Addendum# 1

BID NO.: 101447
OPENING: 1/31/25 at 1:00 PM
COMMODITY: CONSTRUCTION OF NEW LANDS & GROUNDS PAVED MATERIAL LAYDOWN AREA

**BID 101447 – CONSTRUCTION OF NEW LANDS & GROUNDS PAVED MATERIAL LAYDOWN AREA
QUESTIONS AND ANSWERS**

SITE PLAN
 1" = 20'

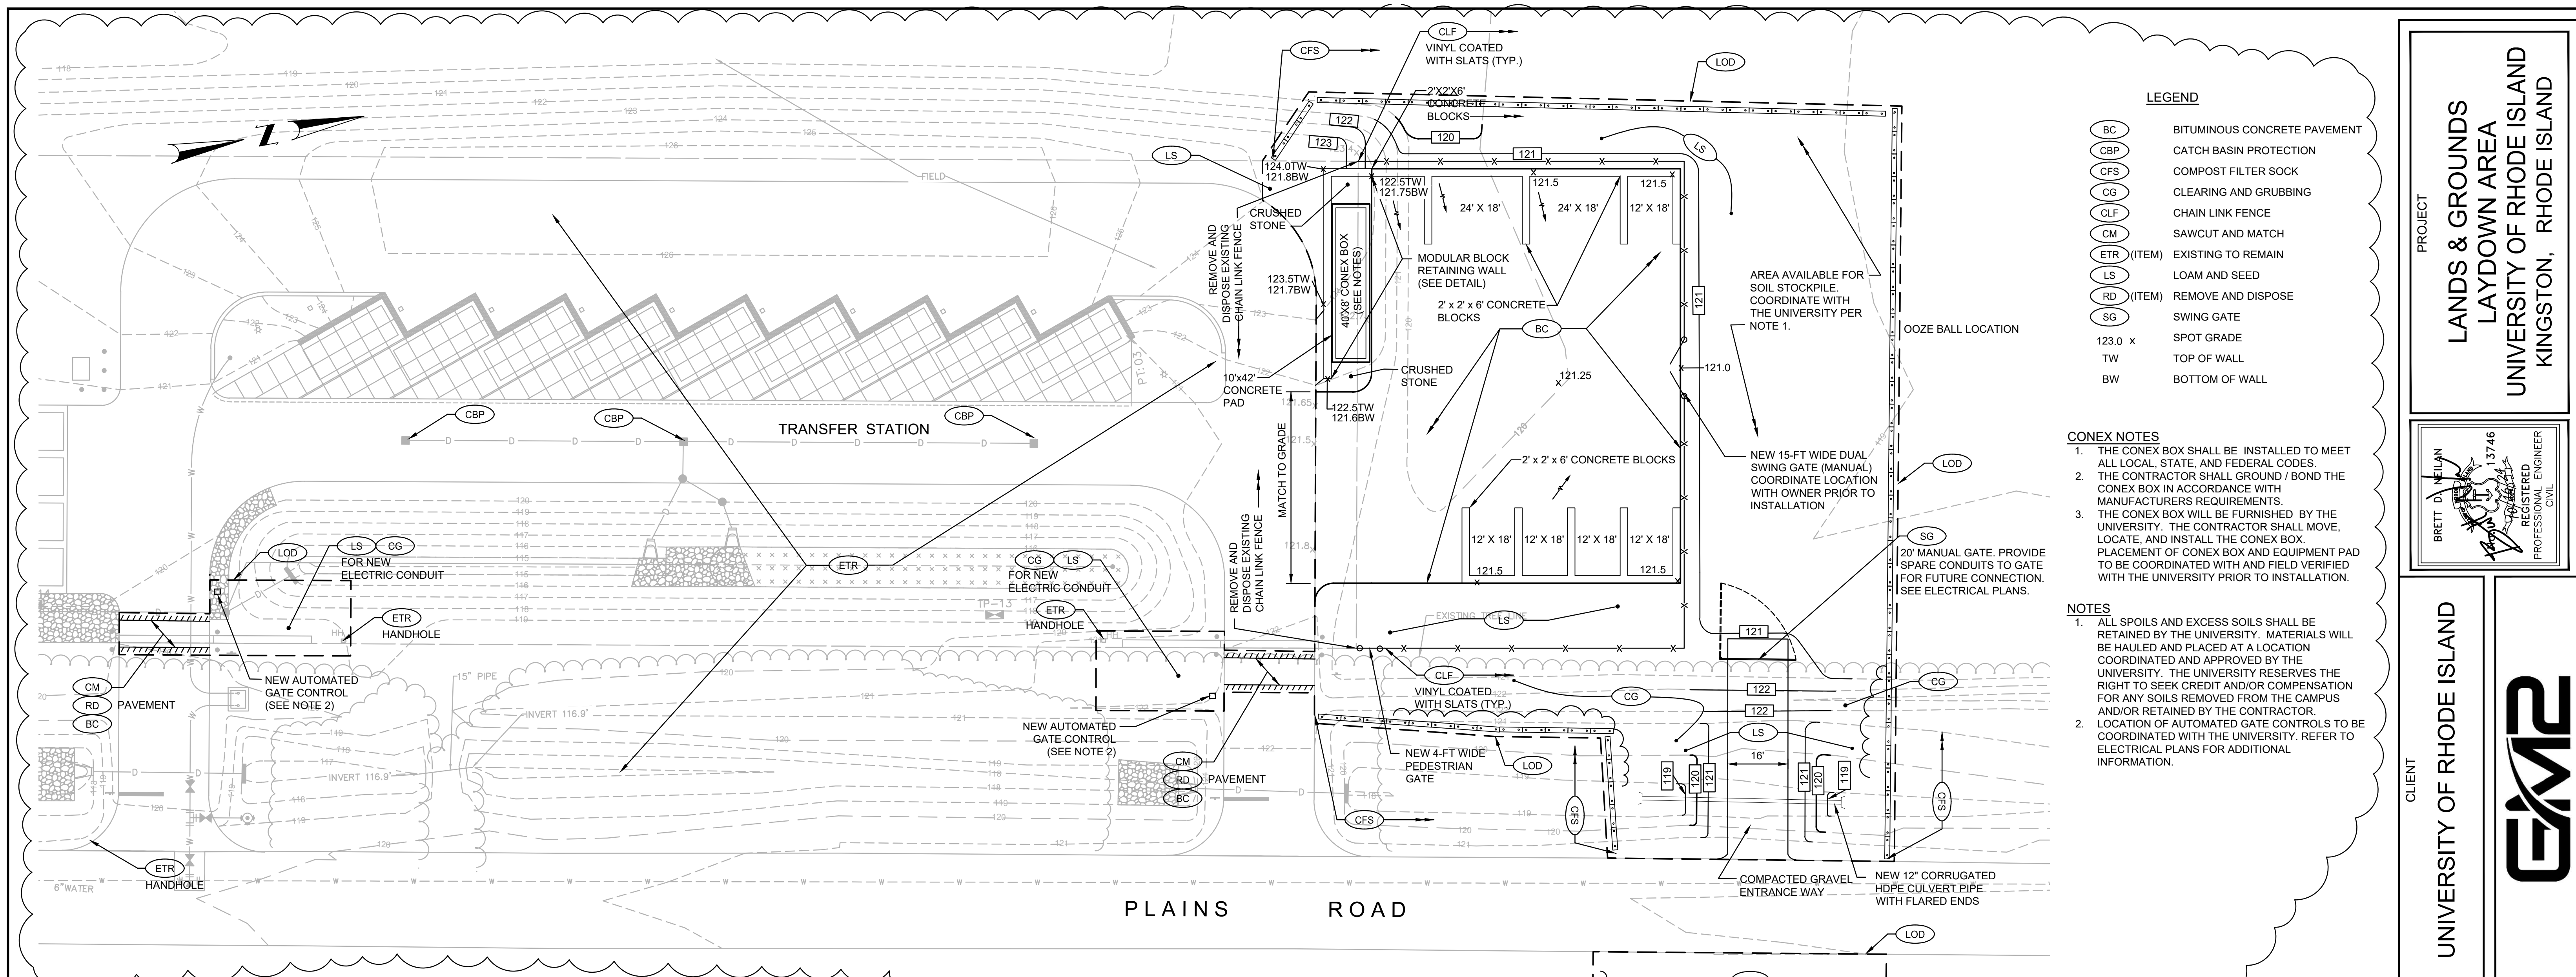
- 1. Retaining/gravity wall is located in a small section. Limits for retaining wall is unclear to estimate length properly. Please call out where the retaining wall is needed and where the ‘mafia block’ wall is needed.**

- 2. Elevation where retaining wall is requested seems to be incorrect on plans, please review and revise if needed.**

- 3. Is 6’ the height wanted for the entire length of wall? Please elaborate.**

- 4. Please call out stock pile area on plans.**

11. There is a detail for a retaining wall in the planset and we cannot find a location/elevations on the site plan.

Answer 1: The retaining wall limits have been defined on the revised plans.

Answer 2: The site topography has been revised in accordance with the as-built information received from the Recycling Depot. Proposed top and bottom of wall elevations are noted on the revised plans.

Answer 3: See response plans and wall detail for elevations.

Answer 4: The soil stockpile area has been indicated on the revised plans.

Answer 11: See responses to Questions #1 and #2.

CONEX BOX PAD DETAIL
 NOT TO SCALE

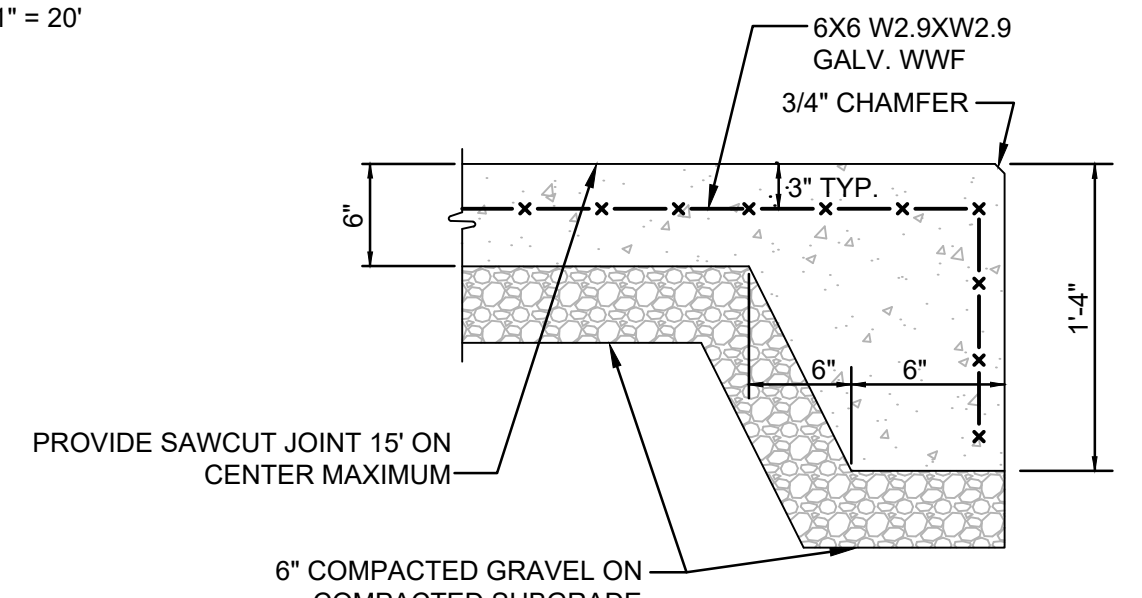
12. Can you provide further specification on the conex box? New or used? Painted? Color?

Answer 12: The conex box has been furnished by the University and is located at the Transfer & Recycling Center. The Base Bid Price shall include the cost for the Contractor to move, position, and ground the conex box per manufacturer's instruction.
